CLIFFORD OUTFALL
ACROSS CITY OF ALBUQUERQUE LAND FILL SITE

TITLE: CLIFFORD OUTFALL
PLAN & PROFILE - OUTFALL CHANNEL

CITY OF ALBUQUERQUE	
MUNICIPAL DEVELOPMENT DEPARTMENT	
ENGINEERING DIVISION	
TITLE:	CLIFFORD OUTFALL MISCELLANEOUS DETAILS

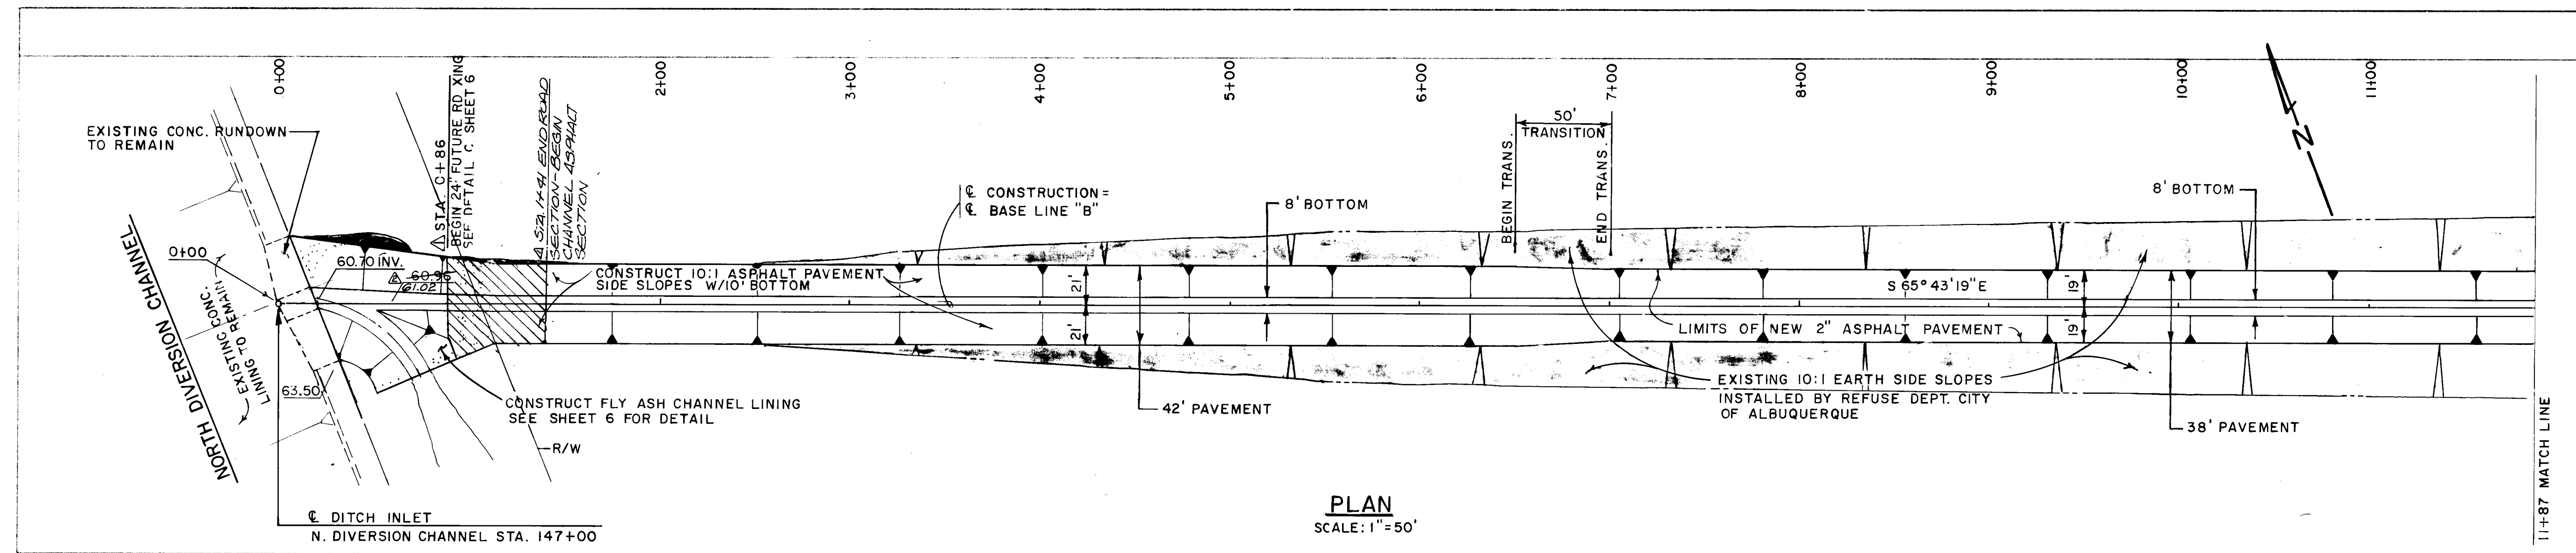
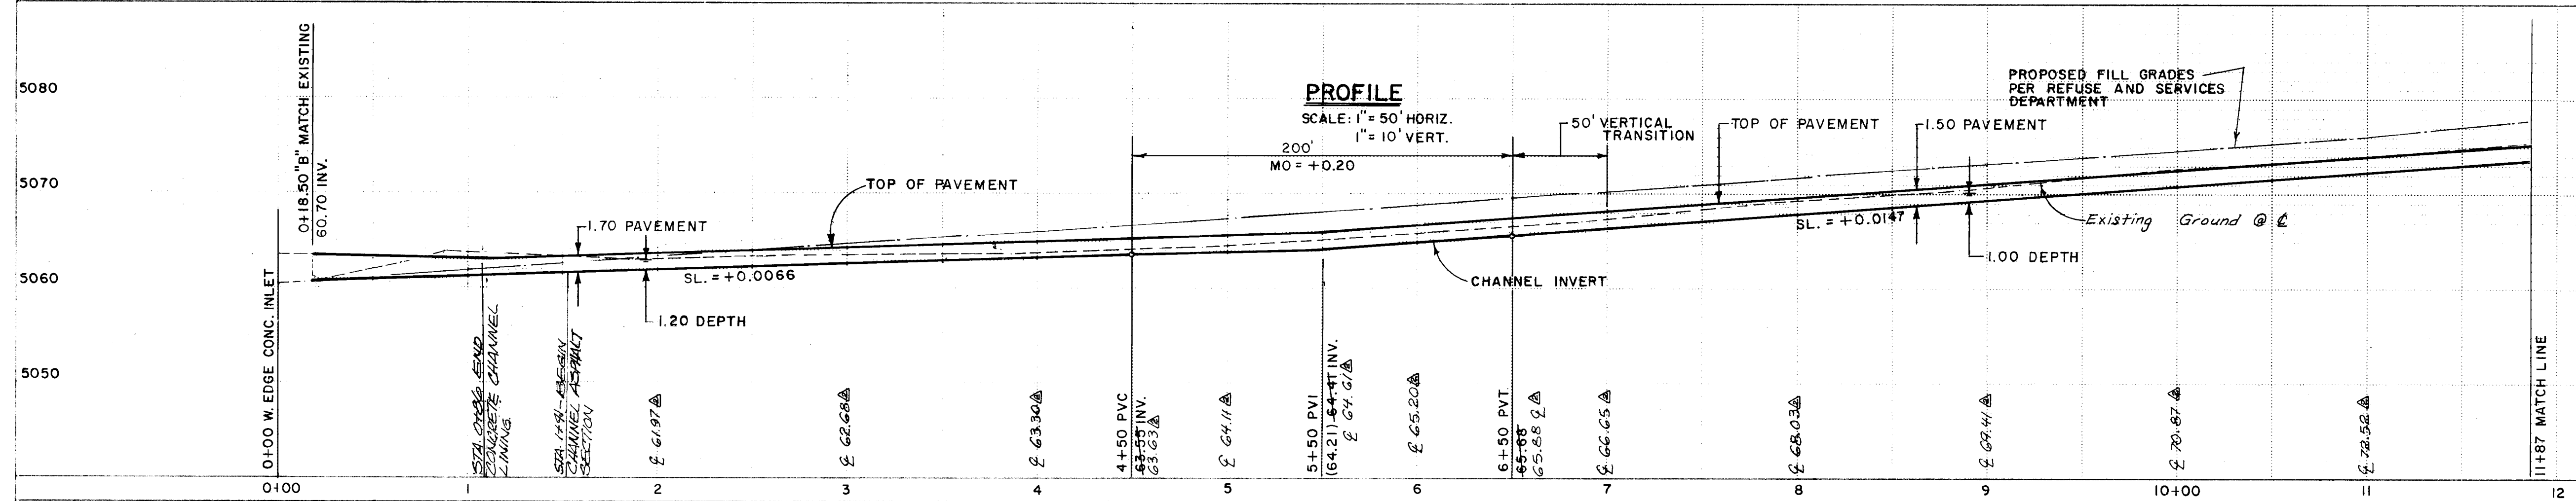
ADD 24' WIDE FUTURE ROAD XING - SEE DETAIL C SHEET 6

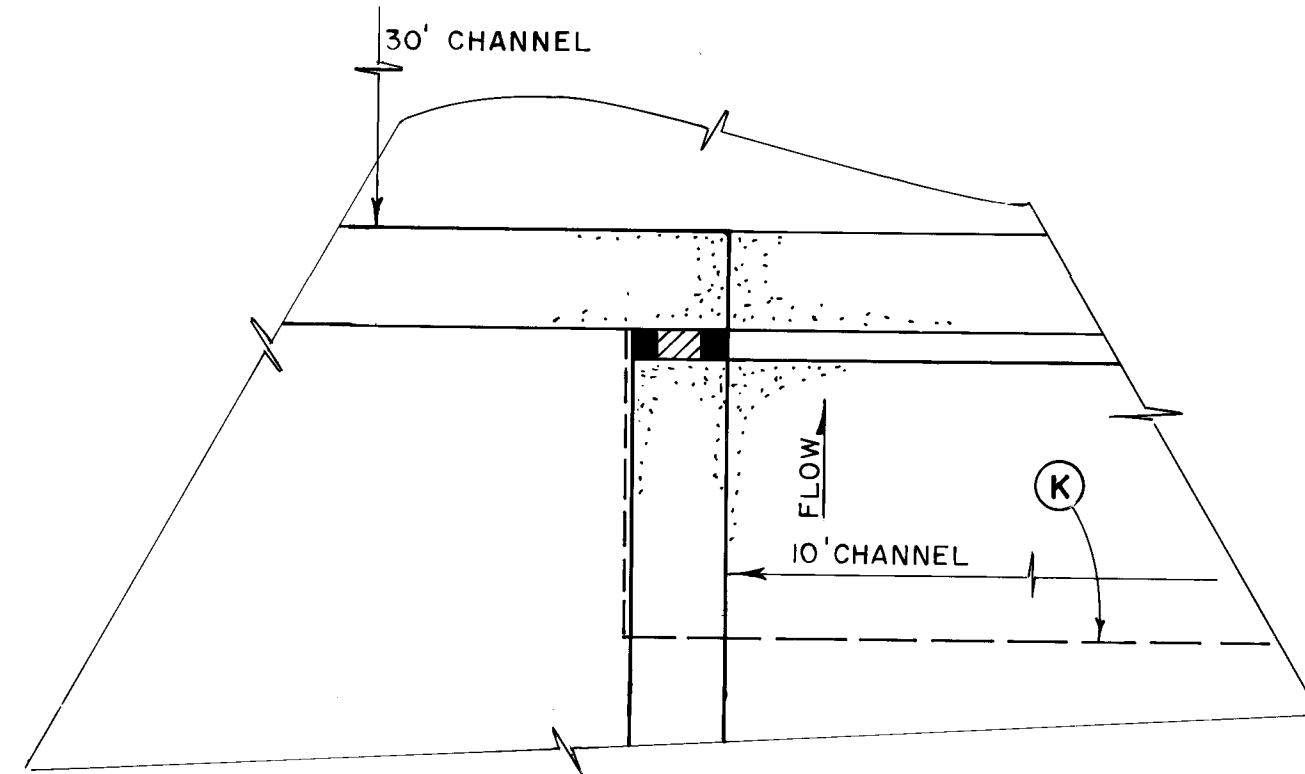
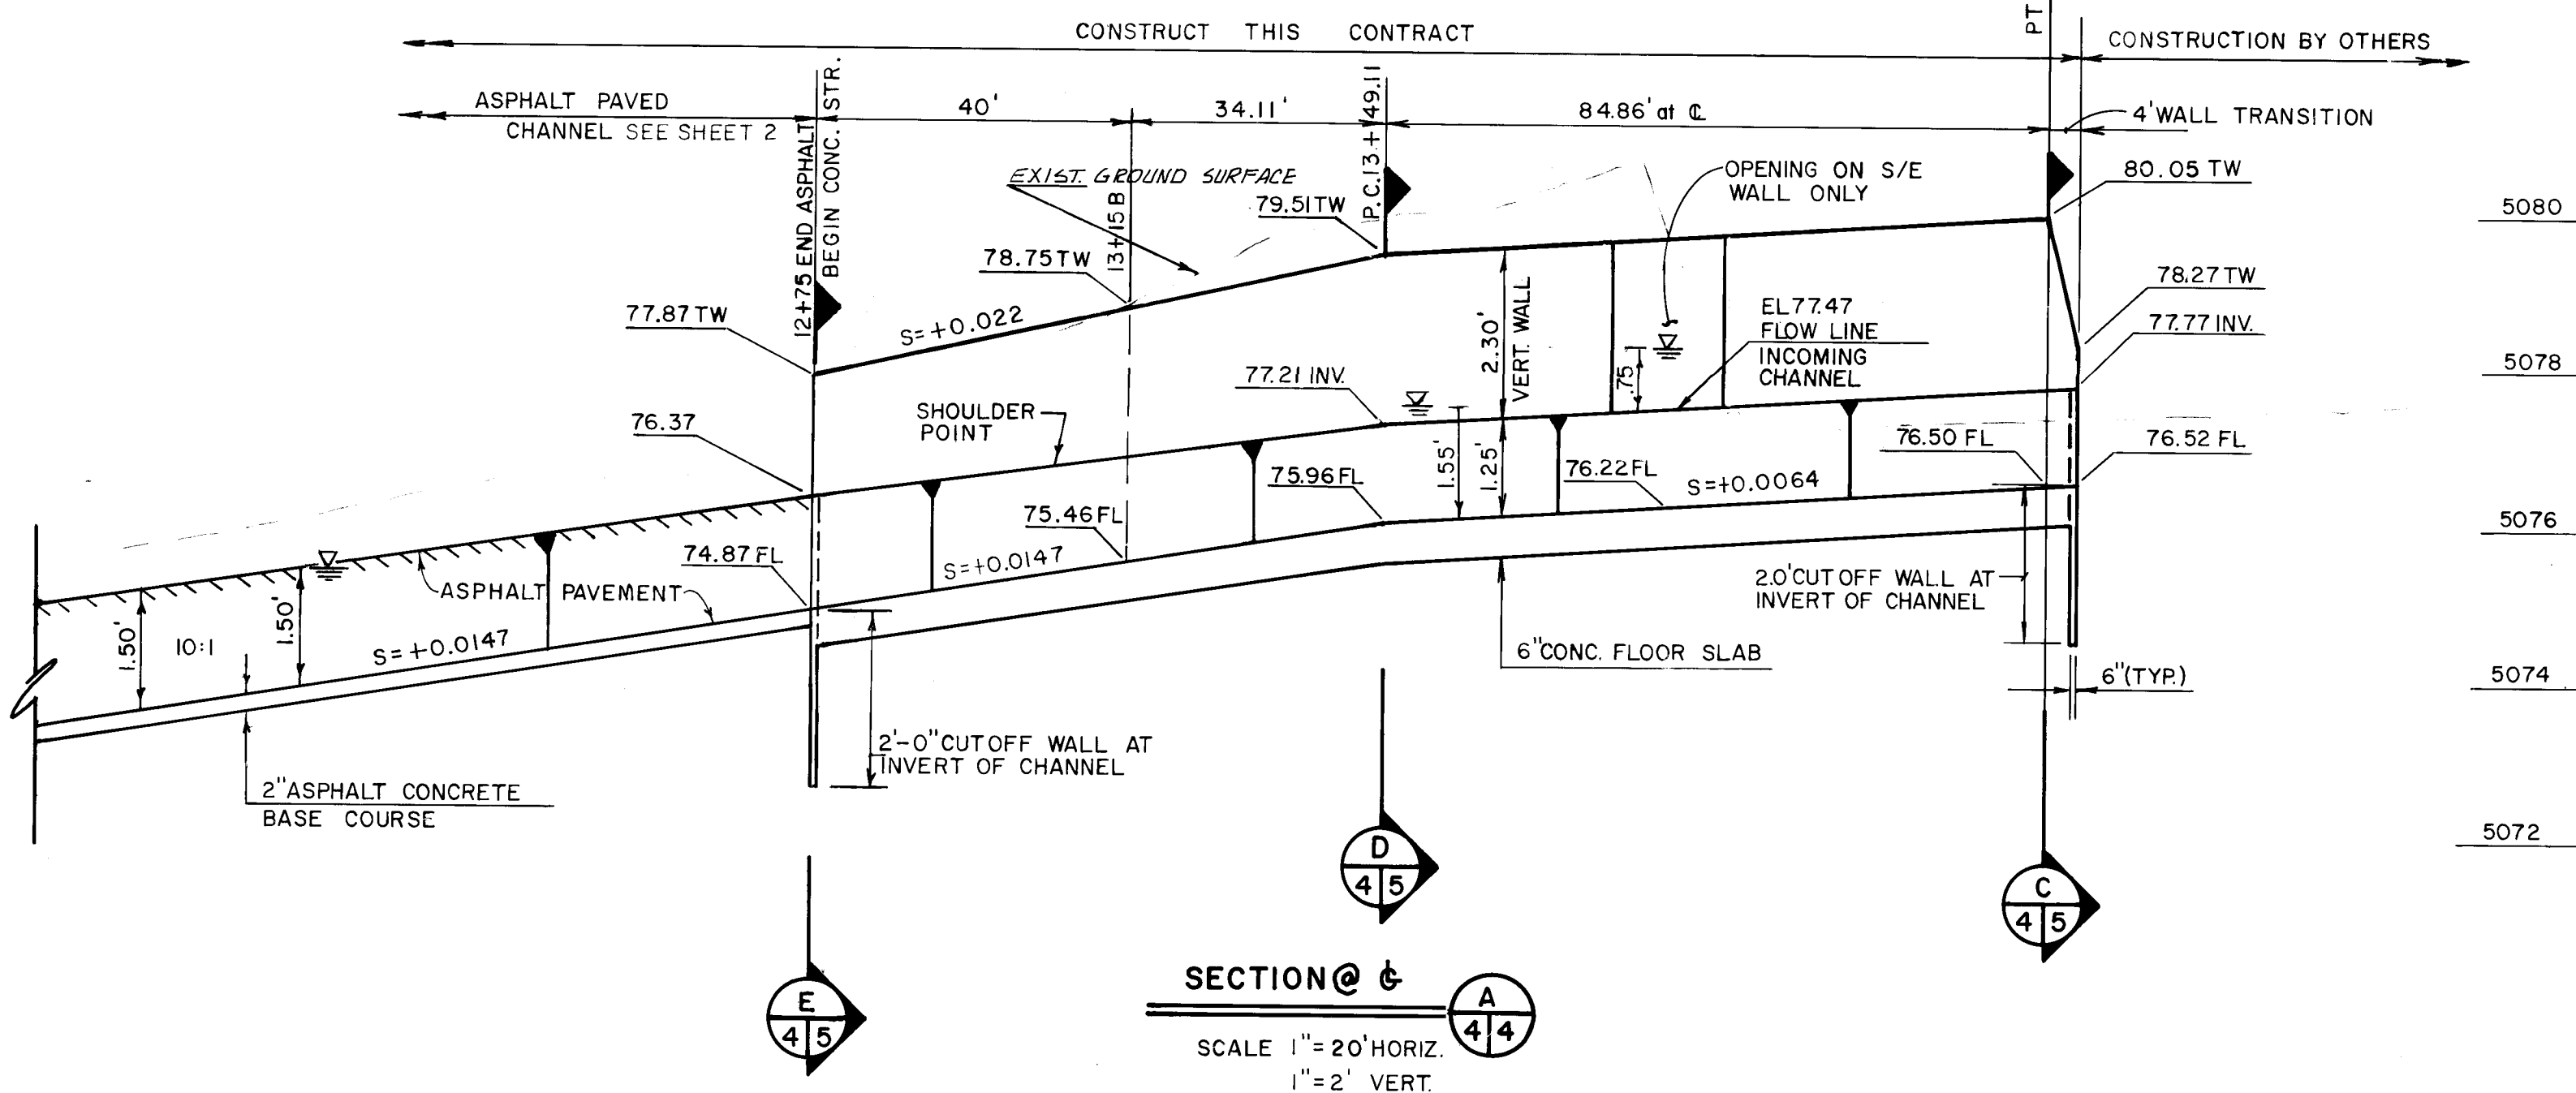
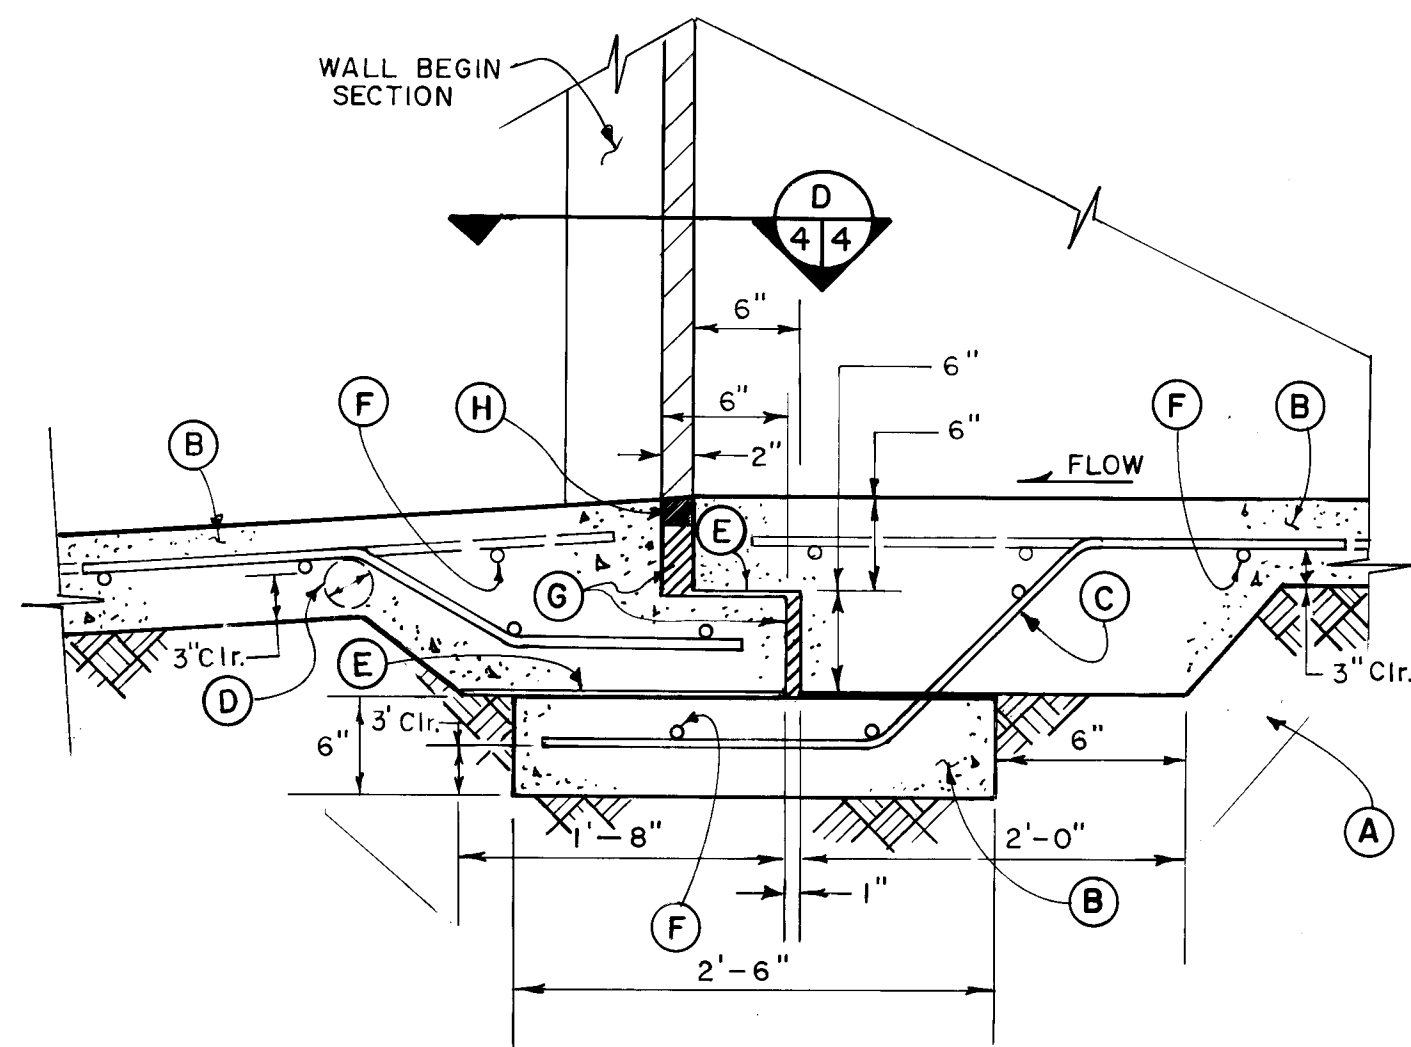
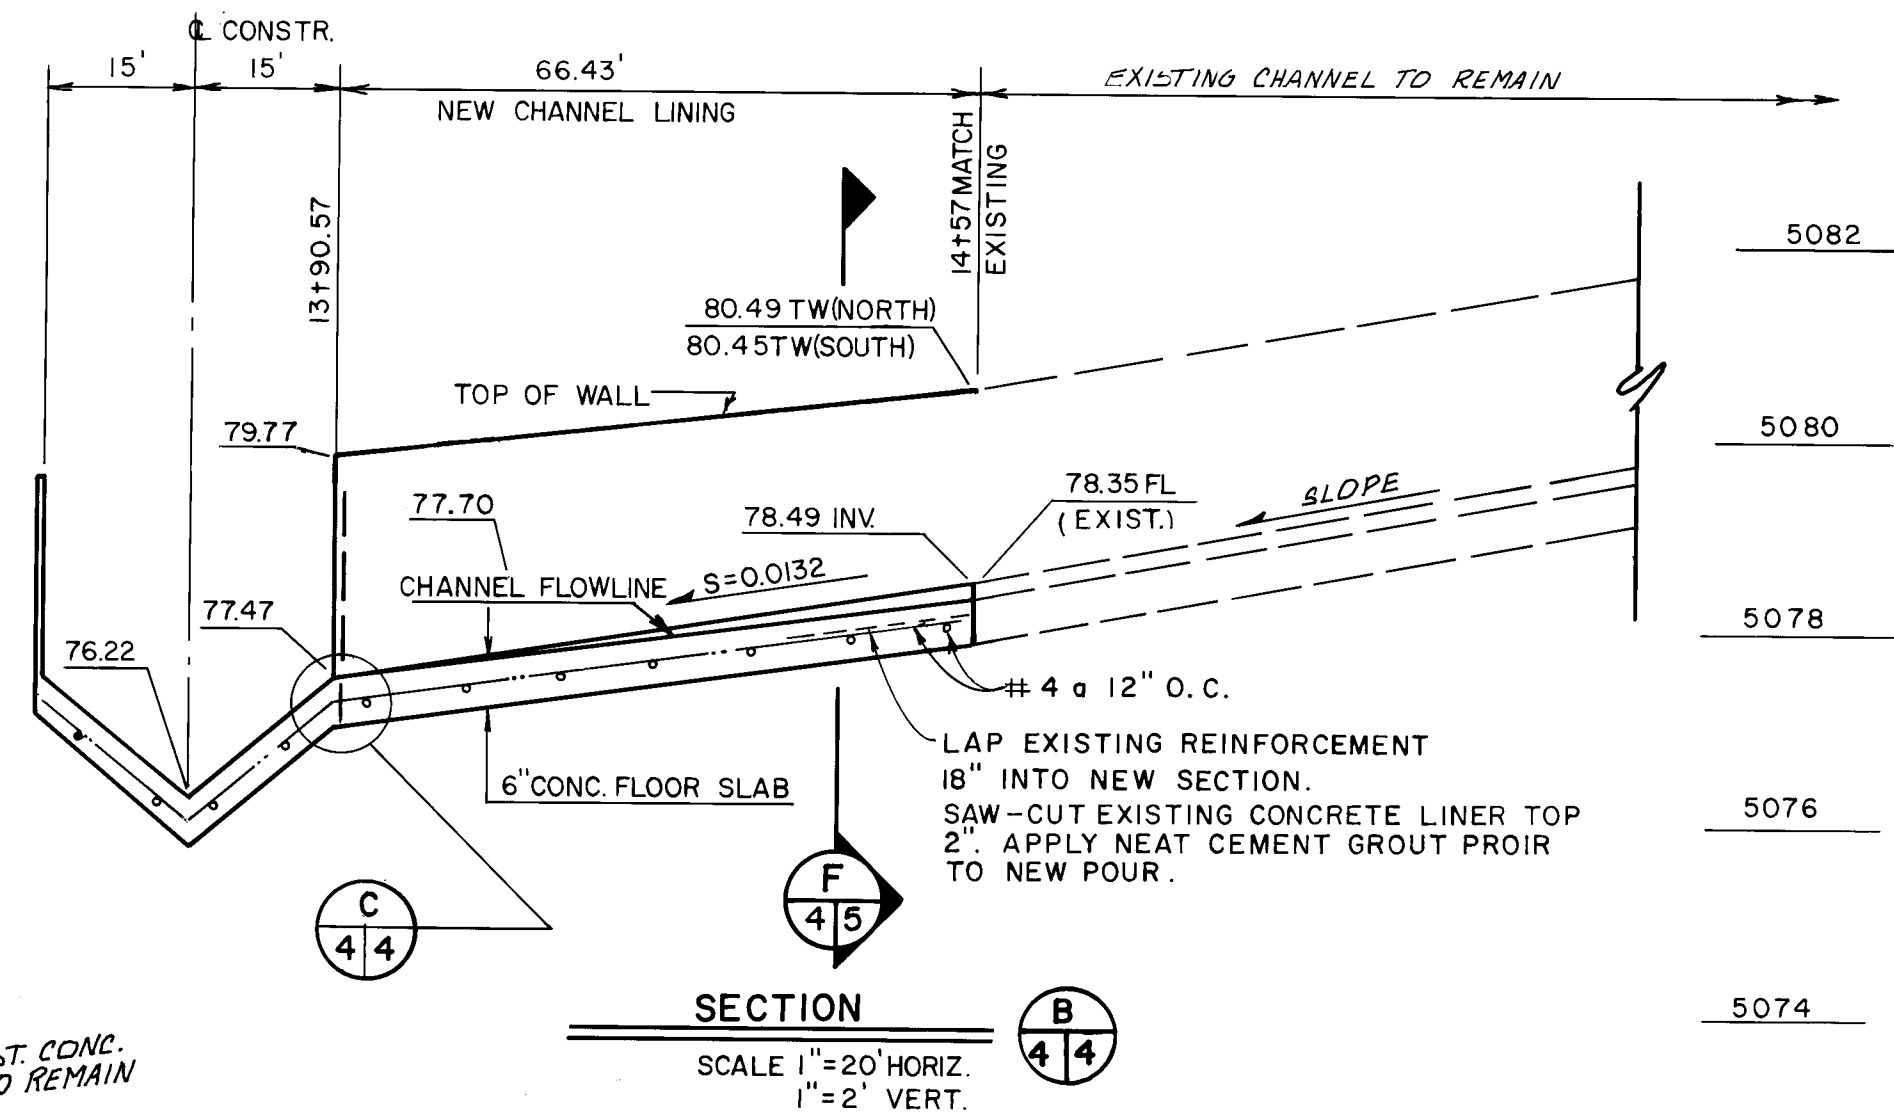
- *** PLAN CORRECTION TO MATCH BID
PROPOSAL. 5/30/85

- 9" EXISTING MATERIAL ABOVE LAND FILL.
- * SECTION 115.04 OF THE SUPPLEMENTAL
TECHNICAL SPECIFICATIONS FOR ASPHALT MIX
REQUIREMENTS ARE REVISED TO READ, BY ADDING:
CHANNEL ASPHALT

1. STABILITY (Marshall - 75 Blows / Face) _____ 1000
2. PER - CENT VOIDS _____ SHALL NOT EXCEED 4 %
3. PER - CENT ASPHALT CEMENT _____ 6.5 - 9.0
4. COMPACTION % OF LAB DENSITY _____ 95 % MIN.

- PROPOSED MIX DESIGN SHALL BE SUBMITTED TO
THE CITY ENGINEER'S OFFICE FOR REVIEW
AND APPROVAL PRIOR TO CONSTRUCTION.
- * PAVING FABRIC SHALL CONFORM WITH SECTION

413.01 THRU 413.03.11 OF THE 1984 EDITION OF
THE NEW MEXICO STATE HIGHWAY DEPARTMENT -
STANDARD SPECIFICATIONS FOR ROAD AND BRIDGE
CONSTRUCTION. SAID SECTIONS TO BE INCORPORATED
INTO THESE CONTRACT DOCUMENT BY THIS REF-
ERENCE. MEASUREMENT PAYMENT SHALL CONFORM
AS SET FORTH IN THE BID PROPOSAL.
